| Request | - | Vacation of all that portion of Whitmer Drive lying between W. Alexis Road and Lyceum Place |

Staff recommends that the Toledo City Plan Commission recommend **approval** of V-58-25, the request for the Vacation of all that portion of Whitmer Drive lying between W. Alexis Road and Lyceum Place, to Toledo City Council for the following **two (2) reasons**:

RIGHT OF WAY VACATION
TOLEDO CITY PLAN COMMISSION
REF: V-58-25
DATE: April 10, 2025
TIME: 2:00 PM

Exhibit "A"
Division of Engineering Services Map

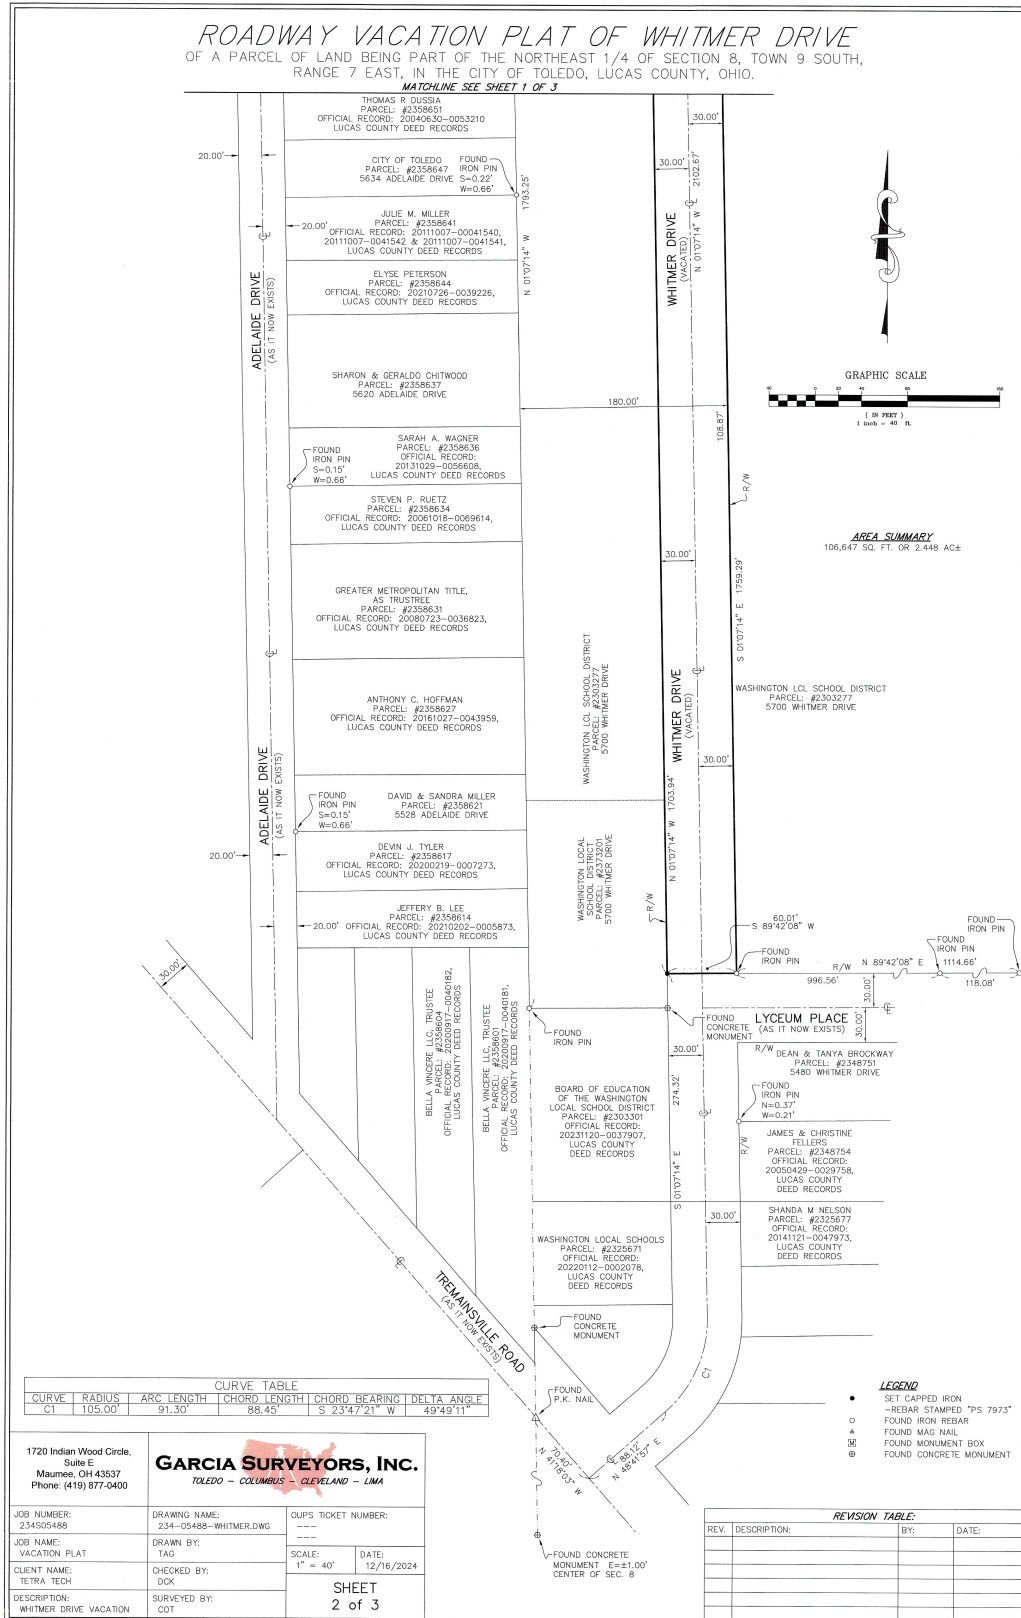
2. An update is needed to the existing easement granted to Toledo by Washington Local for the enclosed Silver Creek. The easement is 30 feet wide, running approximately east-west, except it does not cover the right-of-way. The easement needs to be updated to be continuous where it crosses the vacated land. The current recorded document is number 20160413-0013806.
3. Provide easement for sanitary sewer crossing parking lot and then going down Edgar Street.
4. Show full width easement on Edgar Street per Ordinance 472-72. See attached map in Exhibit A.
